Regulators' Alliance for Progressing  
Infrastructure Development

# Strategic regional water resource solutions: Standard gate one final decision for Vyrnwy Aqueduct

**Figure 2 Submission assessment**

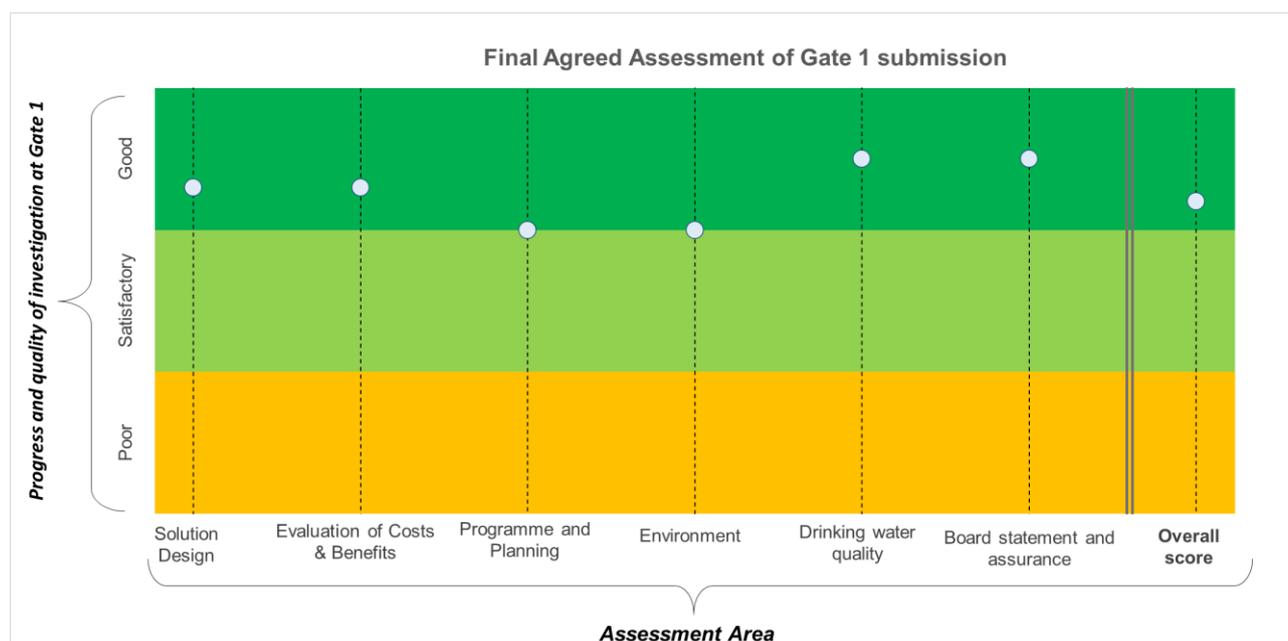
Figure 2 shows our assessment of the work completed on the solution, which was presented in the submission. Our assessment was made against the criteria of robustness, consistency and uncertainty to grade each area of the submission as good, satisfactory or poor in accordance with [our guidance published on 22 February 2021](#). We also assessed the Board assurance provided.

Our overall assessment for the solution submission is that it is good (meets expectations). However, there remain some specific assessment elements where the submission fell short of expectations, which are detailed in the remainder of Section 2.
